Intel[®] Pentium[®] III Xeon[™] Processor Specification Update

Release Date: March 2001

Order Number: 244460-027

The Pentium[®] III Xeon processor may contain design defects or errors known as errata that may cause the product to deviate from published specifications. Current characterized errata are documented in this Specification Update.

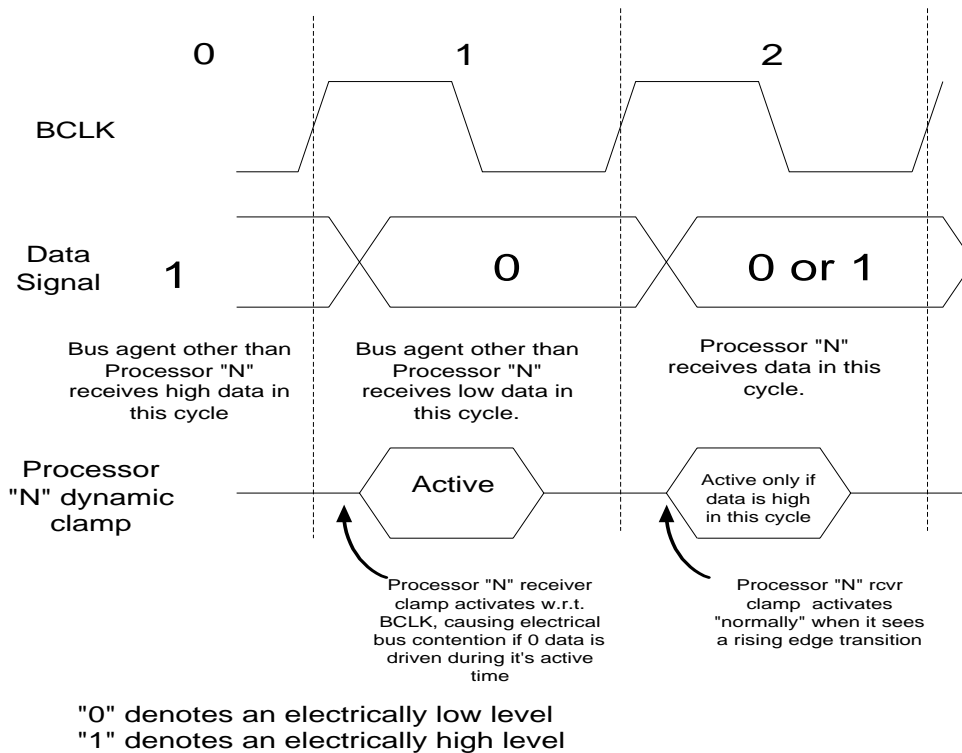
Workaround: The AGTL+ V_{REF} (input voltage reference) level will be raised from 1.0V to 1.1V (assuming a V_{TT} of 1.5V) on the processor cartridge substrate. This allows the dynamic clamp to activate at a trigger level approximately 100 mV higher than with the previous 1.0V V_{REF} setting. Due to the dependence upon system bus design, bus layout may be evaluated to determine the need for improvements in falling edge ringback levels. This may involve one or several of the following baseboard modifications:

1. Change termination resistor value to reduce multi-bit noise and/or improve V_{IL} noise margin.
2. Reduce multi-bit noise by improving ground return paths (additional high-frequency decoupling, improved AC plane referencing, etc.).
3. Raising or lowering the V_{TT} level (within the AC & DC tolerances specified in the processor EMTS) to improve V_{IL} noise margin and/or reduce the multi-bit noise due to dl/dt transients.
